RE: Docket No. 110264-WS; Application for increase in water and wastewater rates in Pasco County by Labrador Utilities, Inc.  
Our File No.: 30057.199

**Utilities Inc. of Florida  
200 Weathersfield Ave.  
Altamonte Springs, FL 32714  
34,000 Gallon Standpipe  
RE: Labrador Reservoir**

**Liquid Engineering Corporation (LEC) Job No. 22191-E**

**Utilities Inc. of Florida  
34,000 Gallon Standpipe  
(LEC) Job No. 22191-E**

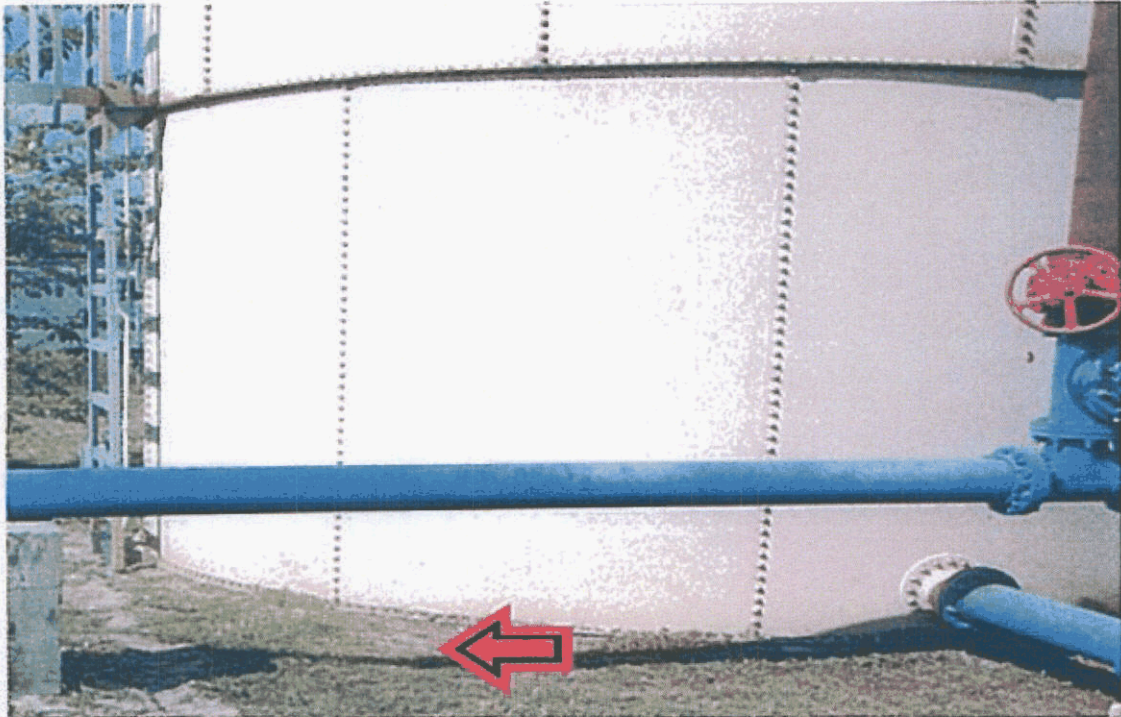
Photo shows the condition of the foundation. We recommend clearing any dirt, debris and other loose gravel away from the tank foundation, down to a minimum 6" below top of foundation as required by AWWA D100-96, Section 12.6.1: Foundations for flat bottom tanks. (see glossary pg. 3). This should be done by a local excavating company.

We further recommend repairing any cracks and spalling in the concrete with a commercial non-shrinking grout, then caulking around the base of the tank to foundation connection to prevent water from entering under the tank and sealing the foundation with a concrete sealant.

We also recommend electrically grounding the tank for lightning protection as required by OSHA, (general duty clause) (see glossary ).

- 3. Repair any cracks and spalling in the concrete with a commercial non-shrinking grout, then caulking around the base of the tank to foundation connection to prevent water from entering under the tank and sealing the foundation with a concrete sealant..... \$1,450

- Electrically ground the tank for lightning protection as required by OSHA, (general duty clause) and NFPA..... \$1,275

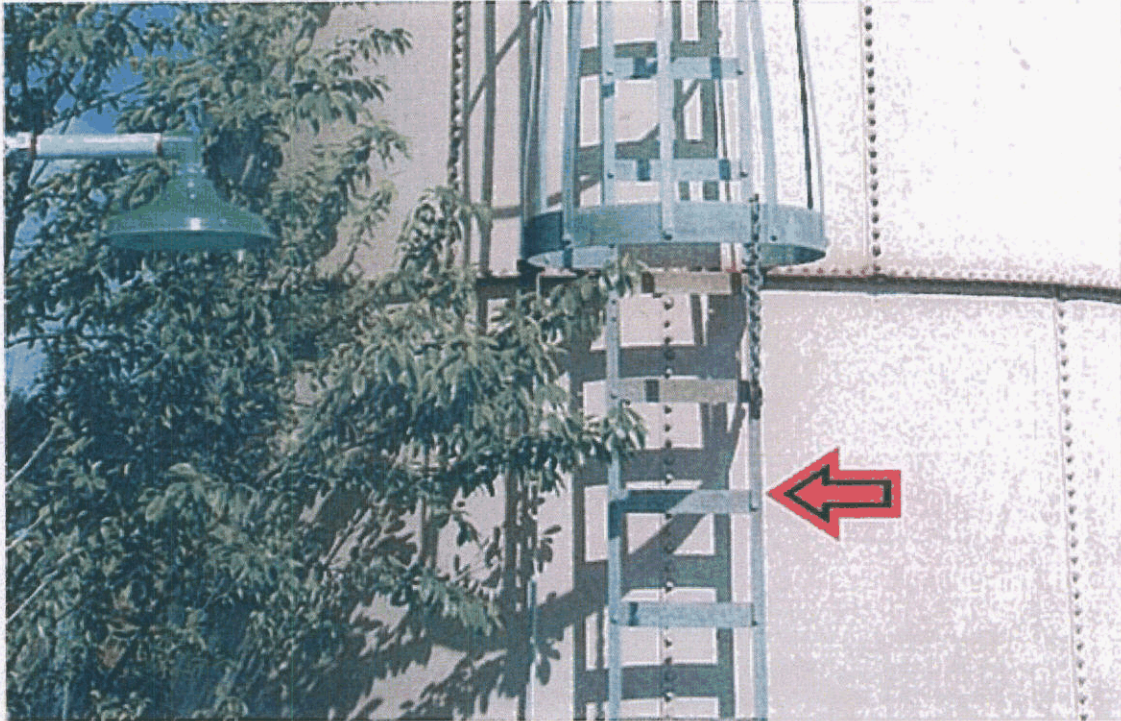
Photo shows the condition of the tank shell. The tank is not equipped with a manway. The following items are required to bring tank in compliance with AWWA D100-96, section 7.1: Shell Manways, OSHA, and TSS, (see glossary pg. 8):

Install a 36" manway

Note: For safety reasons we have recommended a 36" manway instead of the required 24" manway.

- 4. Install 36" primary shell manway ..... \$3,850  
*Substitute a 30" manway for a 36" manway*
- 5. Install a cable type ladder safety climb device ..... \$1,850  
 Post a **Fall Protection Required** sign ..... \$25

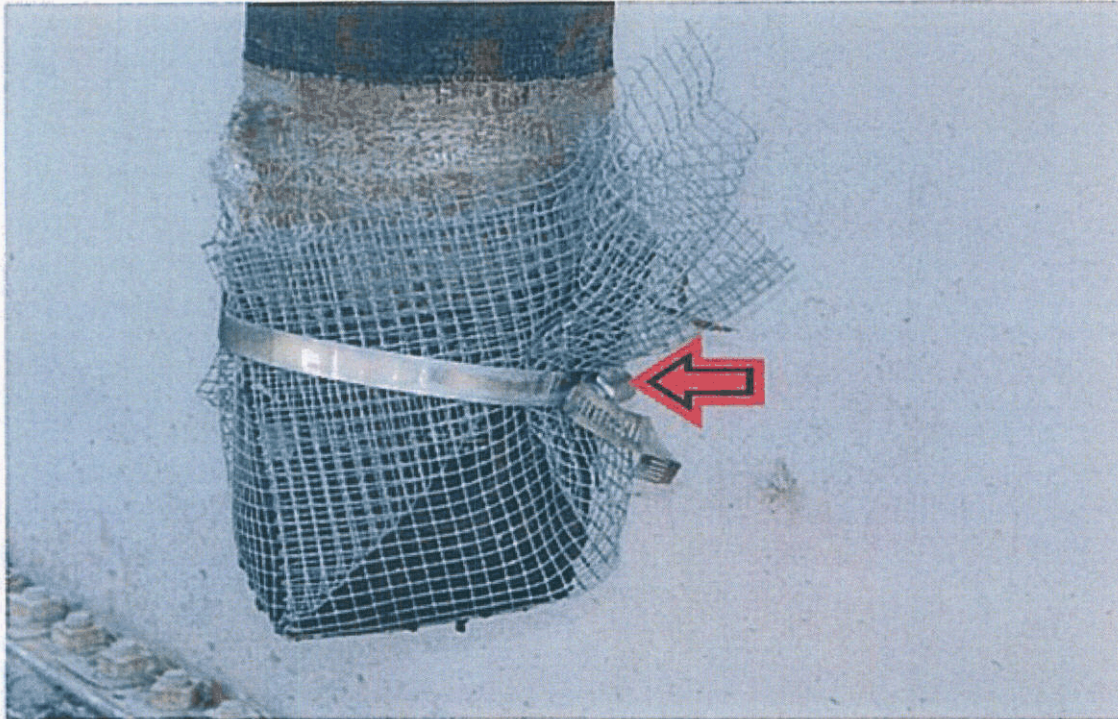
Photo shows the overflow pipe. The overflow pipe is not equipped with a flapper valve. We recommend installing an elbow to direct water away from the tank, a flapper valve and new screen on the existing overflow pipe and a splash pad to direct water away from the tank foundation.

- 6. Install an elbow, a flapper valve and new screen on the existing overflow pipe and splash pad to direct the water away from the tank's foundation..... \$1,150

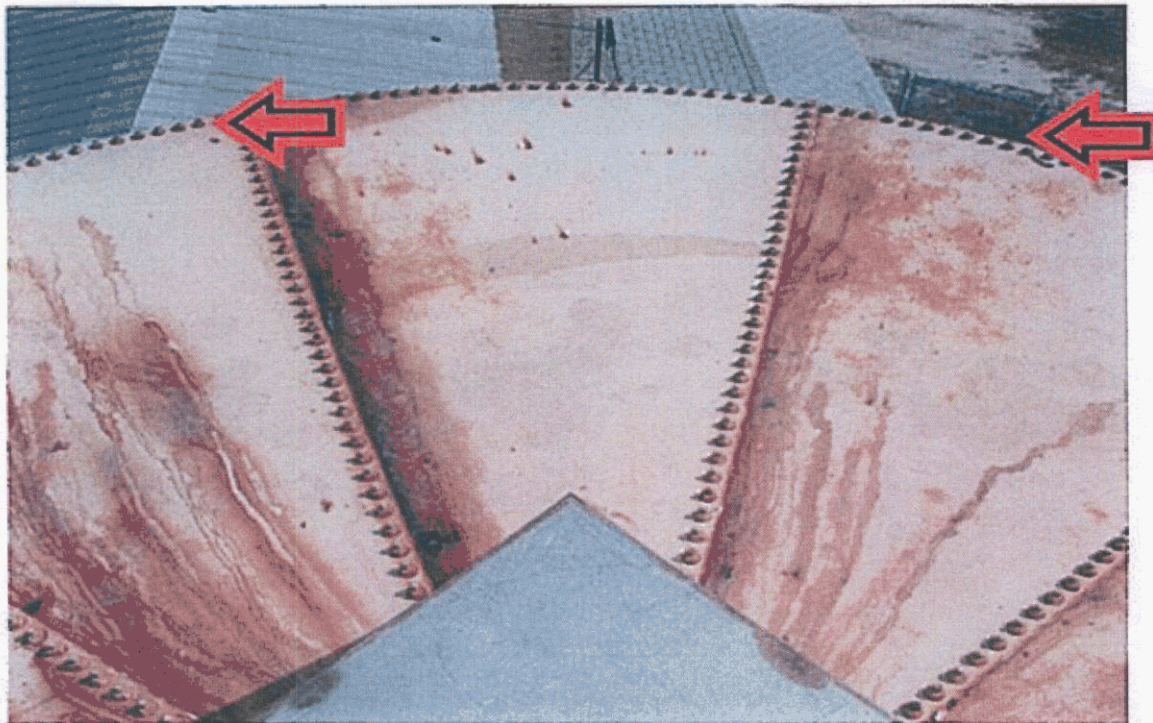
Photo shows the tank roof is not equipped with an OSHA required fall protection system. We recommend installing an approved 42" high handrail system around the circumference of the tank roof, complete with toeboard, intermediate rail and a stainless steel gate chain at the junction of the shell-to-roof access ladder and tank roof as required by OSHA (see glossary).

- 7. Install an approved 42" high handrail system around the circumference of the tank roof, complete with toeboard, intermediate rail and a stainless steel gate chain at the junction of the shell-to-roof access ladder and tank roof as required by OSHA ..... \$2,345

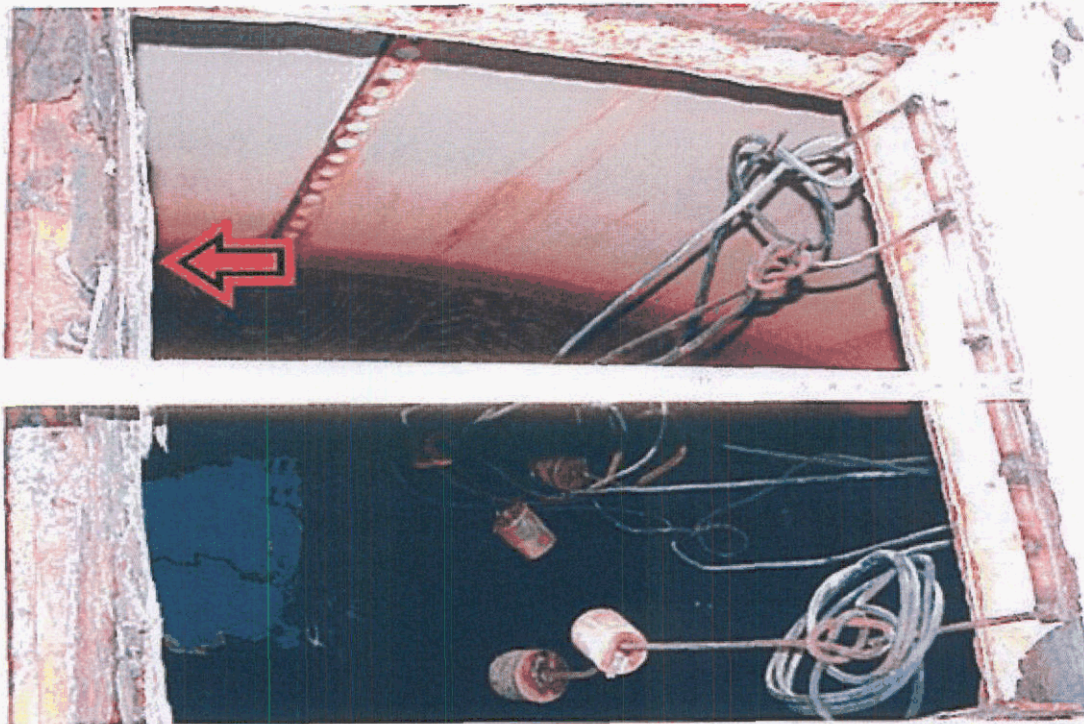
Photo shows the condition of the roof manway. Notice the manway curb is severely deteriorated. Roof openings on this tank require the following to be in compliance with OSHA, AWWA and TSS Section 7.0.8: Access, (see glossary pg. 23):

Replace existing manway with 36" manway

Install exterior platform for rescue tripod, complete with tripod and winch

Note: For safety reasons we have recommended a 36" manway instead of the required 24" manway.

- 8. Replace existing roof manway with 36" manway..... \$3,350  
 Install exterior platform for rescue tripod complete with tripod and winch .... \$5,000  
 Replace the existing roof vent with a vacuum-pressure, frost proof vent and screen in compliance with AWWA..... \$4,810

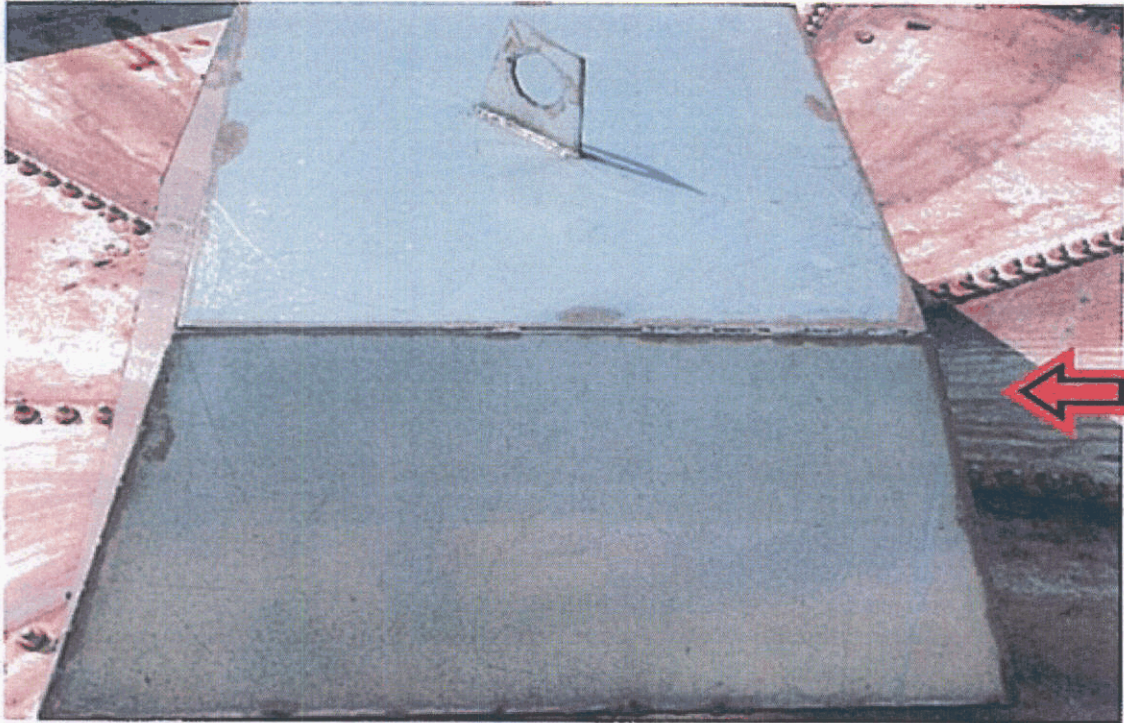
Photo shows the condition of the existing roof vent. **An improperly vented tank may cause external pressure to act on the tank which can cause buckling even at low pressure differential.** We recommend replacing the existing roof vent with a vacuum-pressure, frost proof vent and screen in compliance with AWWA and TSS, (see glossary).

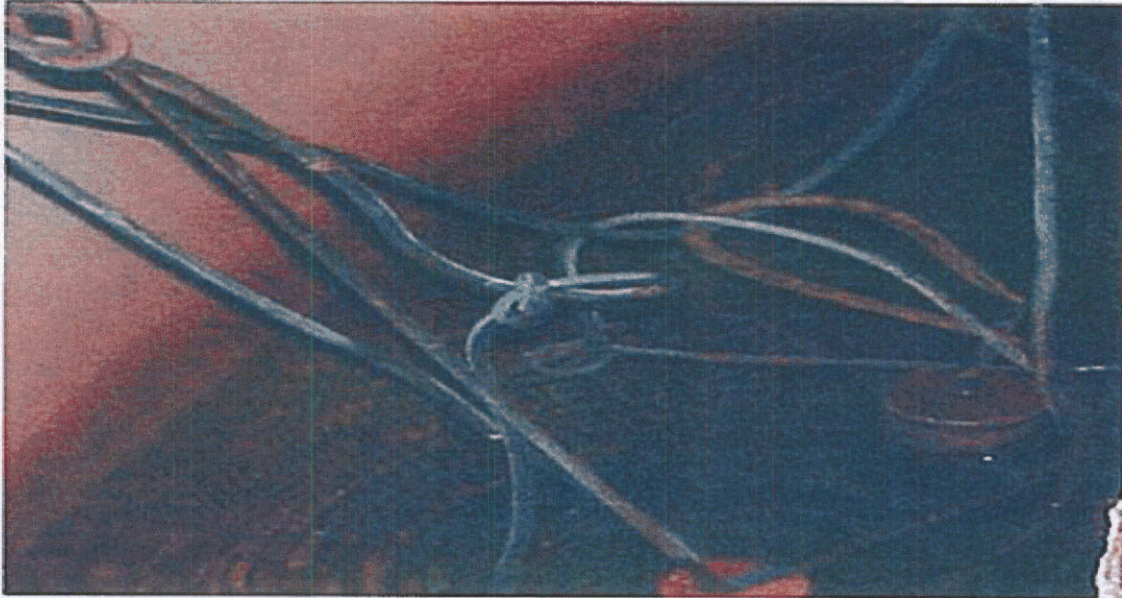
Photos show the condition of the exterior paint system. We recommend sand-blasting the tank exterior to an SSPC #6 (commercial) blast, apply one (1) full coat of primer, then applying one (1) finish coat of Alkyd.

- 10. EXTERIOR PAINT SYSTEM: Sandblast all rusted and abraded areas of the tank exterior to an SSPC #6 (commercial) blast, brushblast all remaining areas, apply one (1) full coat of epoxy-mastic and one (1) finish coat of urethane ..... \$11,500
